REPORT/RECOMMENDATION

To:	**MAYOR AND COUNCIL**	**Agenda Item**	**Item No. VI.B.**
From:	**Cary Teague, Community Development Director**	☒	**Action**
		☐	**Discussion**
Date:	**March 6, 2012**	☐	**Information**
Subject:	**PUBLIC HEARING – Rezoning from PCD-4 to PUD, 6996 France Avenue, FE 70, LLC, Ordinance No. 850-A-38 and Resolution No. 2012-39**		
Deadline for a City Decision:	**May 1, 2012**

ACTION REQUESTED:
Adopt Ordinance No. 850-A-38 and Resolution No. 2012-39 approving Final Rezoning from PCD-4, Planned Commercial District to PUD, Planned Unit Development District, and Final Development Plan to construct an 8,260 square foot retail/office building at 6996 France Avenue for FE 70, LLC.

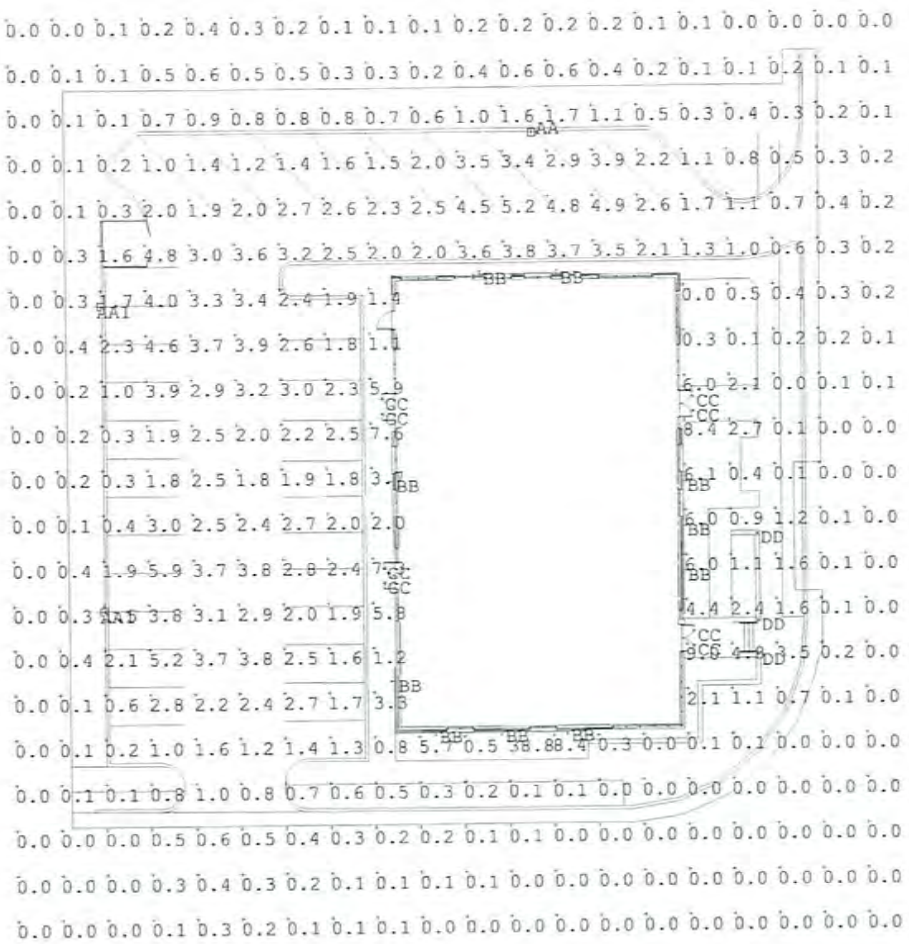
10) Submit a photometric lighting plan that details illumination levels sufficient to support an active pedestrian movement along France Avenue and West 70th Street.

Commissioner Schroeder said he observed that the plans as presented do not adequately illustrate site and building lighting. Schroeder said lighting was important especially as it relates to pedestrian movement. Continuing, Schroeder said in his opinion the final plan doesn't present sufficient illumination levels to support active pedestrian movements.
